FINAL
AS-BUILT BASELINE
MONITORING REPORT (MY0)

MAJOR HILL STREAM AND WETLAND MITIGATION SITE
Alamance County, North Carolina

DMS Project ID No. 100015
Full Delivery Contract No. 7193
USACE Action ID No. SAW-2017-01472
DWR No. 17-0921
RFP No. 16-006990

Subject: Major Hill Stream and Wetland Mitigation Site: As-built Comment Responses
DMS Contract #: 7193; DMS Project ID: 100015; RFP # 16-006990

FIGURE
B

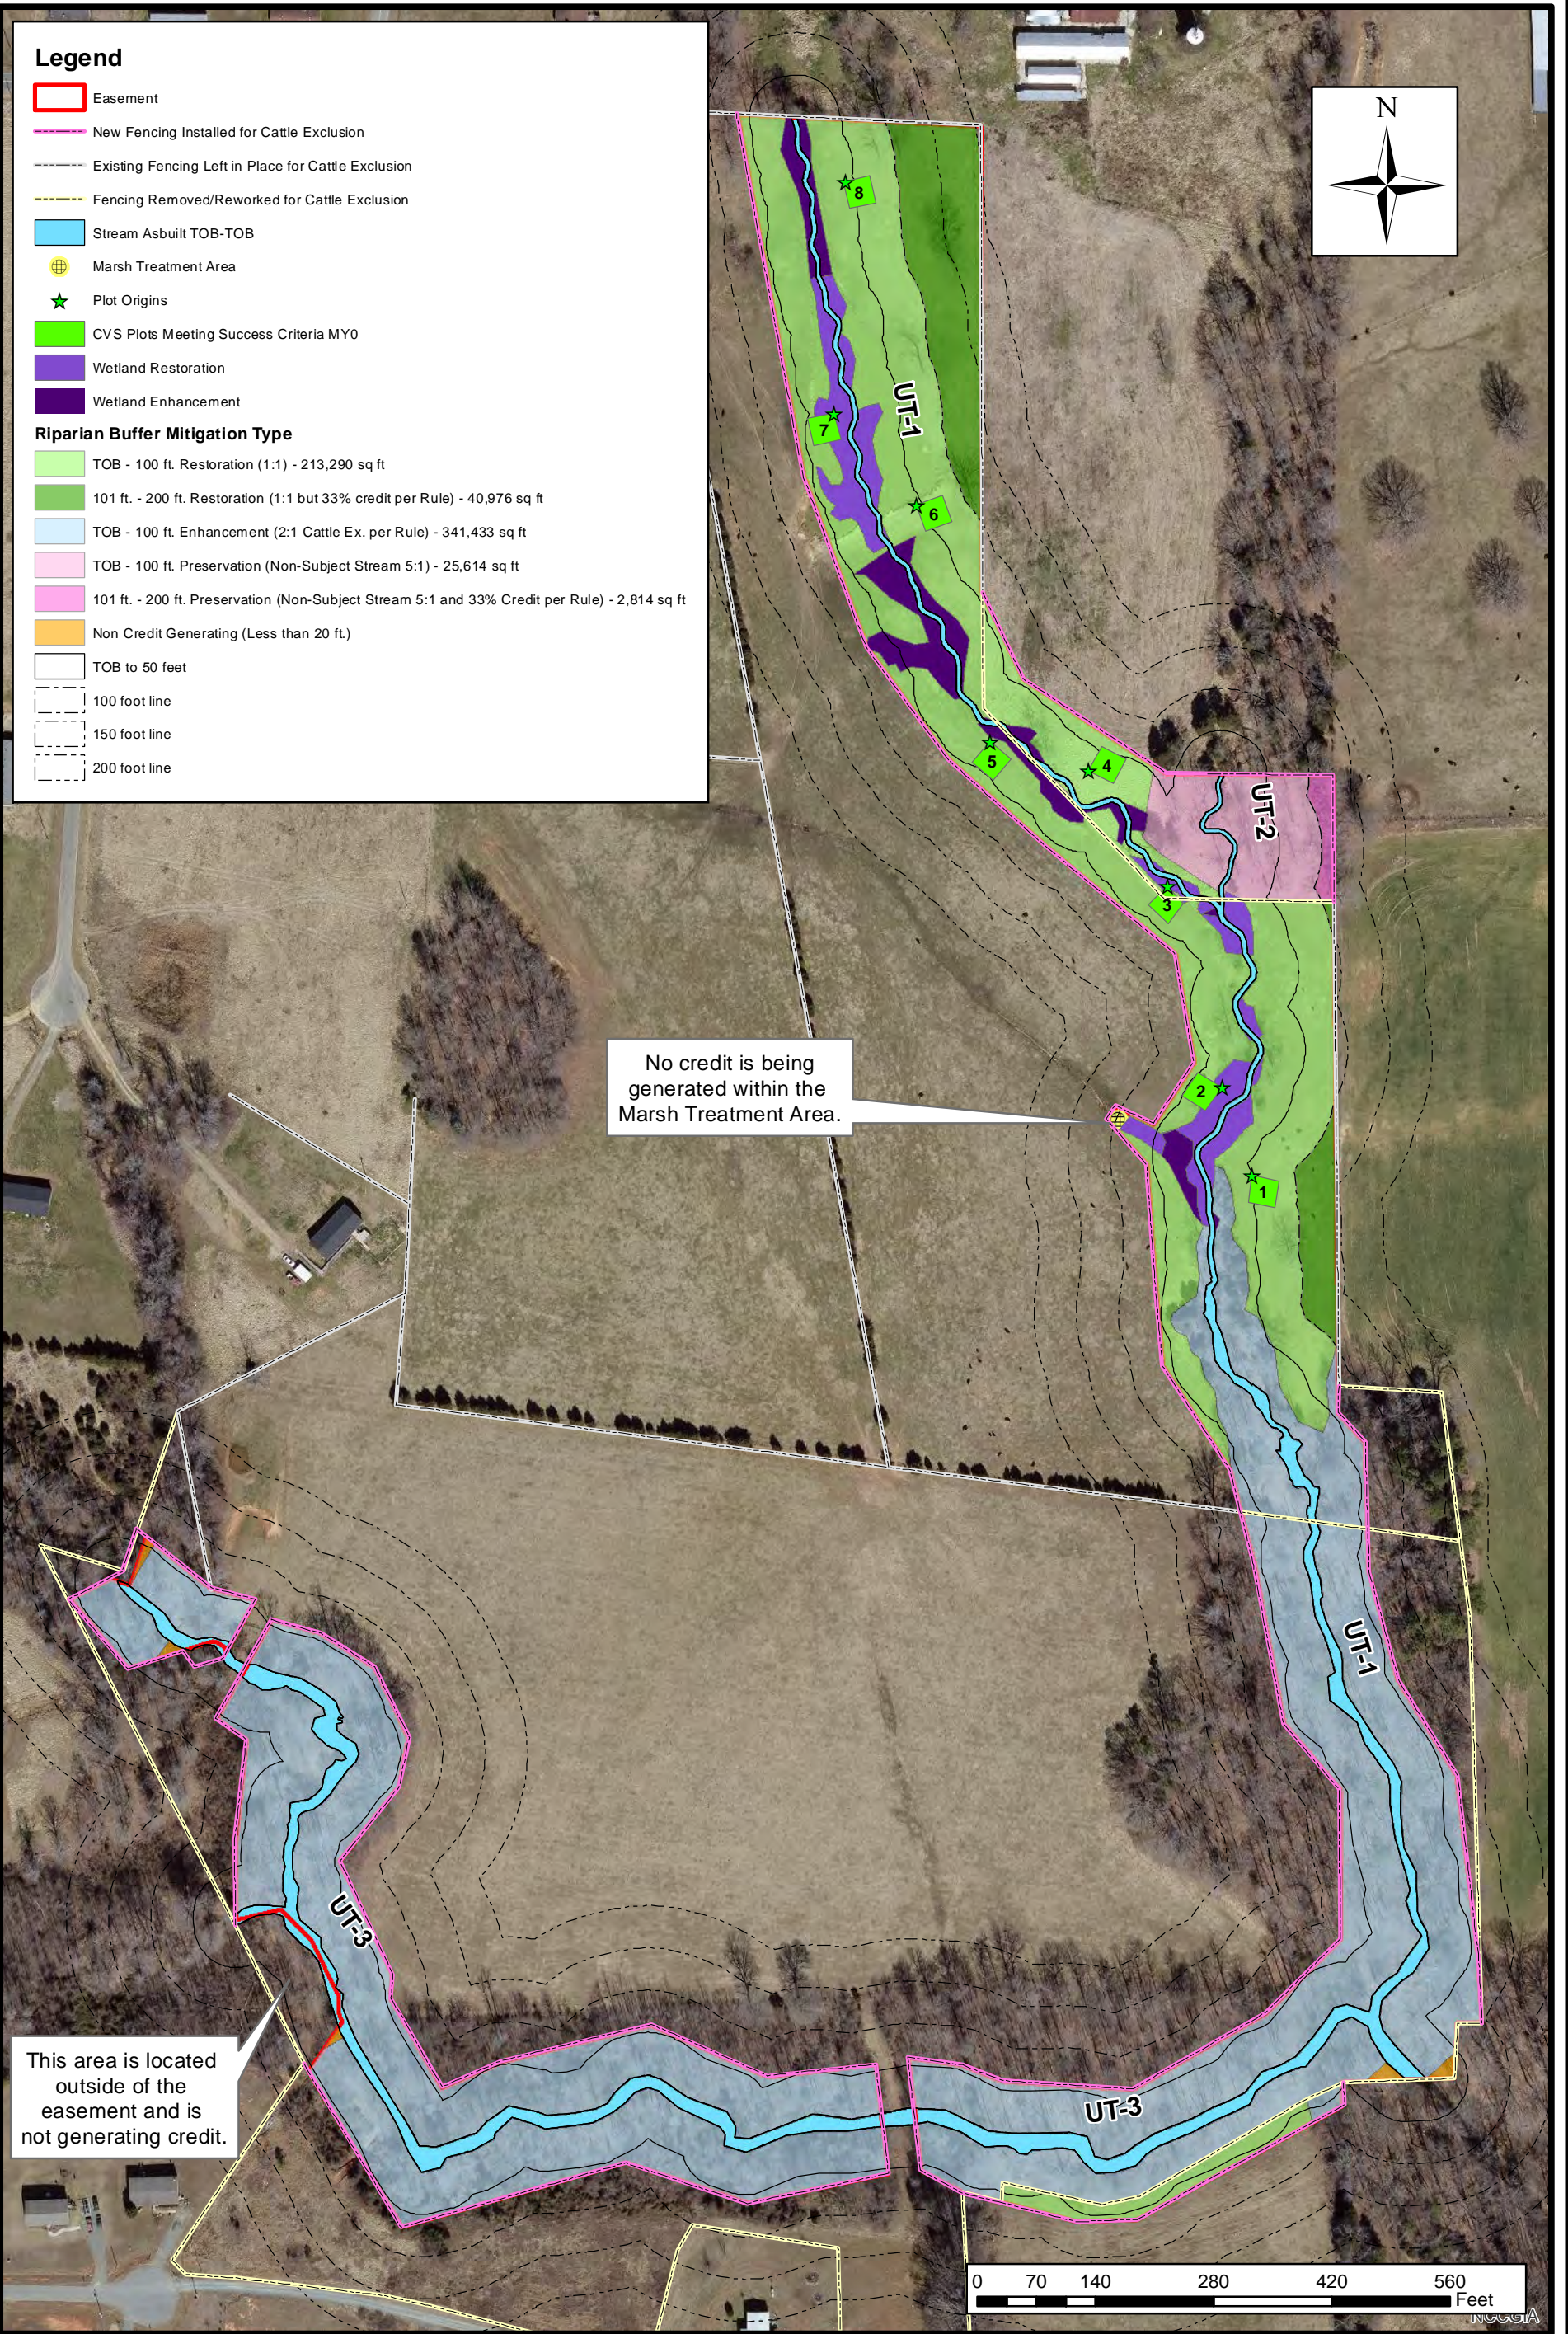
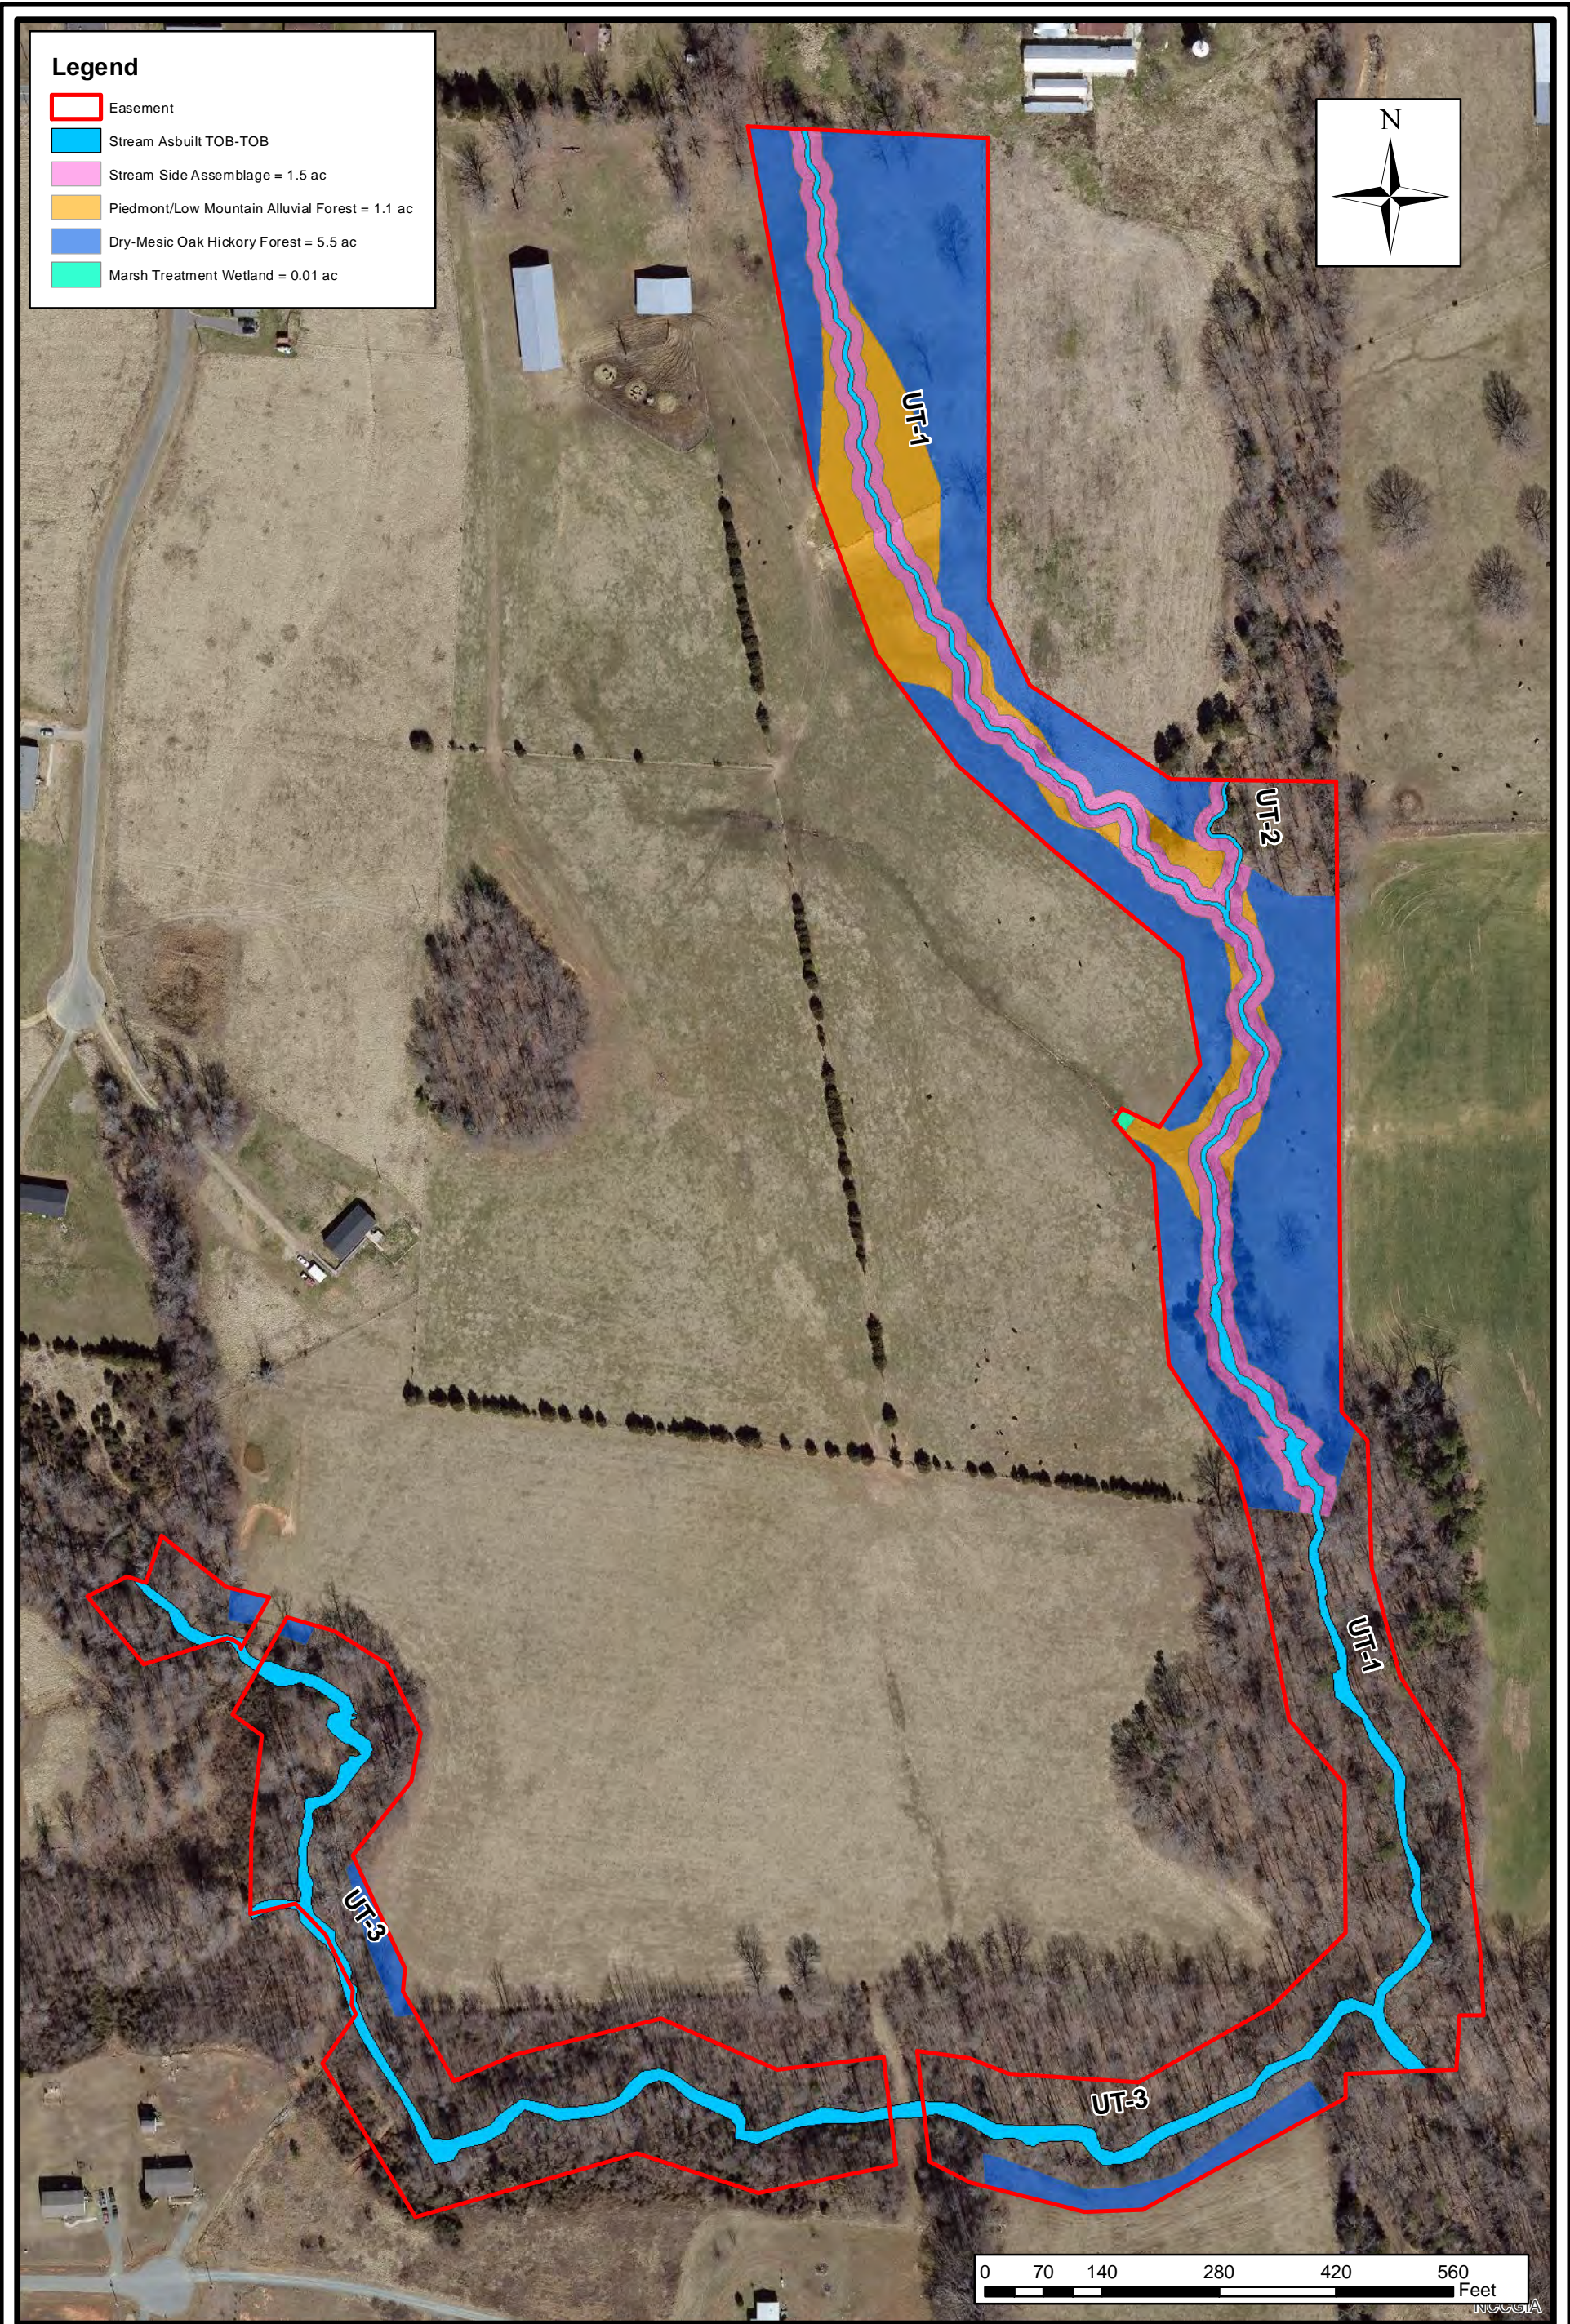
- Provide a planting map and show by planting zone and acreage (same as wetland and stream report). *A planting map (Figure B) was created with planting zones and acreages.*

Detailed Plan – Figure 6 (Restoration Plan) Stationing

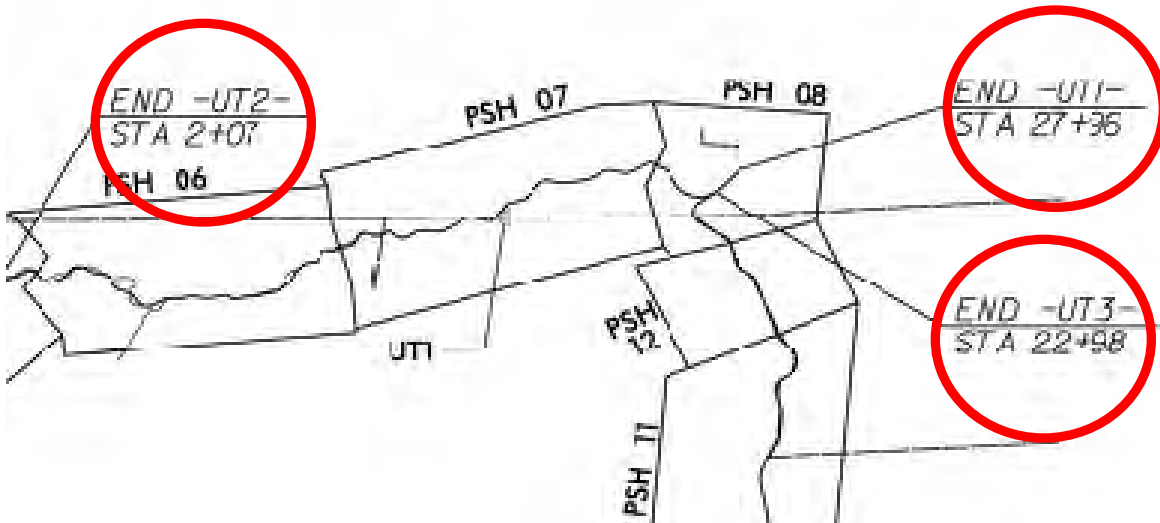
- Stationing: why does UT-1 only go out to ~1,675 and UT-2 only go to 28'? Shouldn't you be showing the distances as stationing as in the design? *As discussed in the field, stationing on the profile and stationing of the alignment are independent. The alignment is based on the centerline along the plan view, while the profile is based on field measurements and will inherently be different. The profile is not expected to match the alignment which is used for crediting purposes.*

Please note, Construction Plan and As-built stationing are consistent. The discrepancy between the Detailed Restoration Plan and Construction Plans are not certain, but likely result from easement boundary changes between Detailed Plan figure development and Construction Plan preparation, GIS conversion errors, and/or typographical error. These problems are being resolve for future submissions.

The final Asbuilt stationing matches the Construction Plans and depict what was constructed/enhanced at the Site.
